UNITED STATES
NUCLEAR REGULATORY COMMISSION
WASHINGTON, D. C. 20555

WISCONSIN ELECTRIC POWER COMPANY
DOCKET NO. 50-266
POINT BEACH NUCLEAR PLANT, UNIT NO. 1
AMENDMENT TO FACILITY OPERATING LICENSE

ATTACHMENT TO LICENSE AMENDMENTS

SAFETY EVALUATION BY THE OFFICE OF NUCLEAR REACTOR REGULATION

FIGURE 15.3.10-1
CONTROL BANK INSERTION LIMITS
POINT BEACH UNITS 1 AND 2

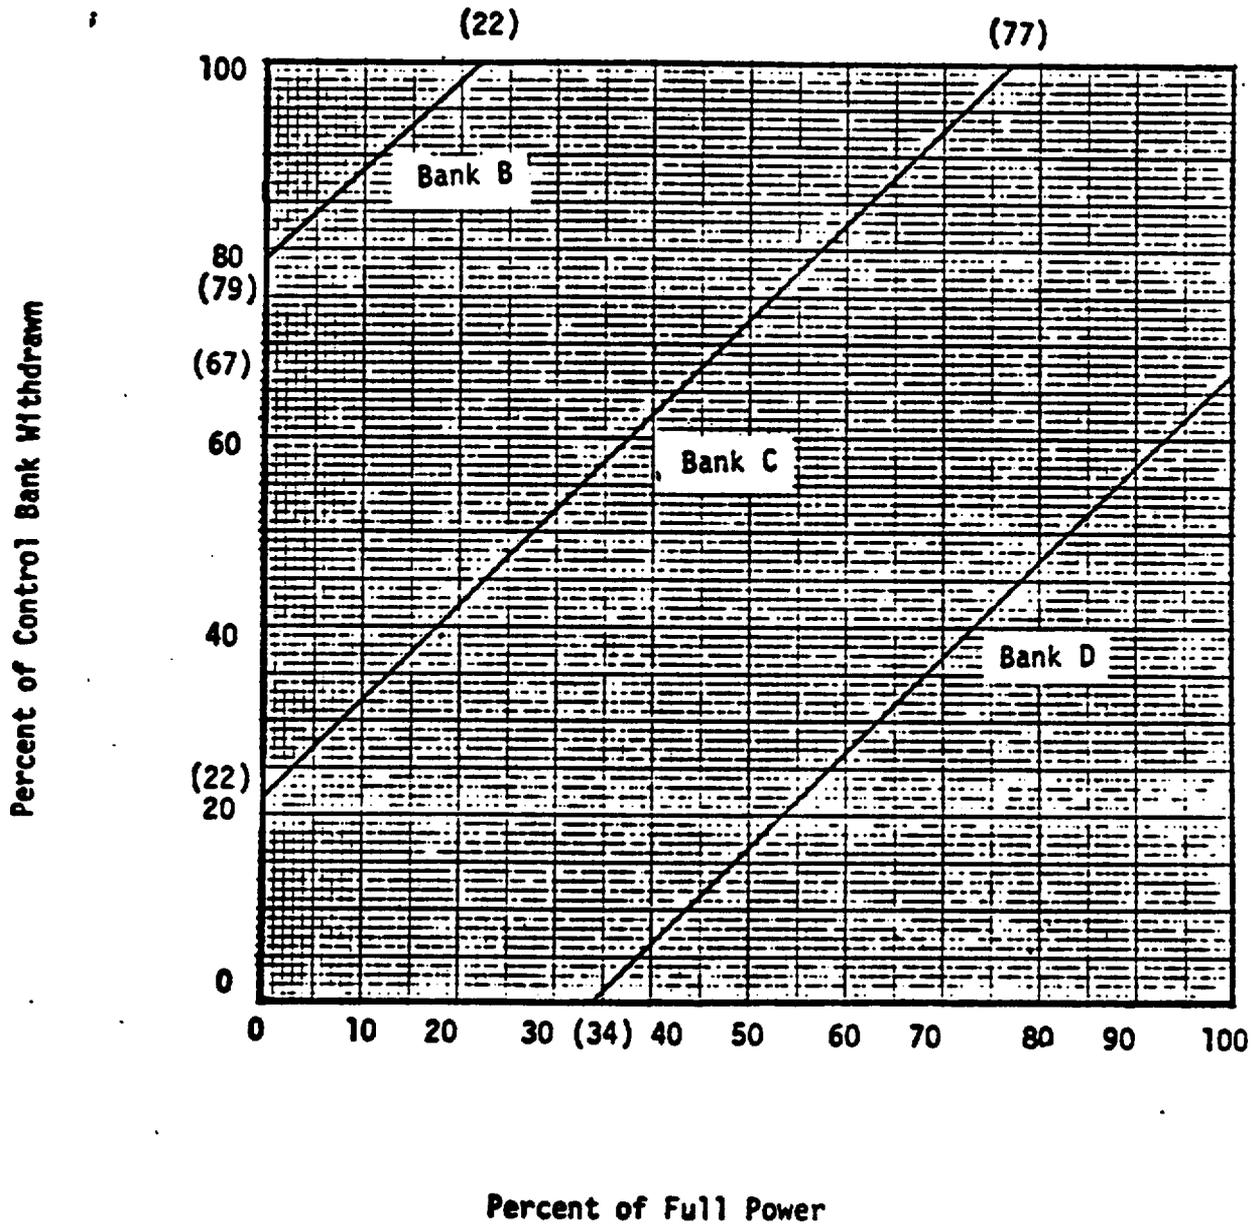
These amendments revise Technical Specification 15.3.10 to define the "fully withdrawn" condition of a control rod as equal to or greater than 225 steps withdrawn. Your request also proposed a revised figure 15.3.10-1, "Control Rod Insertion Limits," which deleted reference to the number of steps withdrawn and instead graphed "percent of control bank withdrawn" to "percent of full power." This change has already been incorporated into Unit 2 Technical Specifications by issuance of amendment No. 90 to Facility Operating License DPR-27. Therefore this portion of your change request shall be applicable to Point Beach Unit 1 only.

1. When the reactor is critical, except for physics tests and control rod exercises, the shutdown banks shall be fully withdrawn. ⁽¹⁾
2. When the reactor is critical, the control banks shall be inserted no further than the limits shown by the lines on Figure 15.3.10-1. Exceptions to the insertion limit are permitted for physics tests and control rod exercises.

(1) Fully withdrawn is defined as a bank demand position equal to or greater than 225 steps. This definition is applicable to shutdown and control banks.
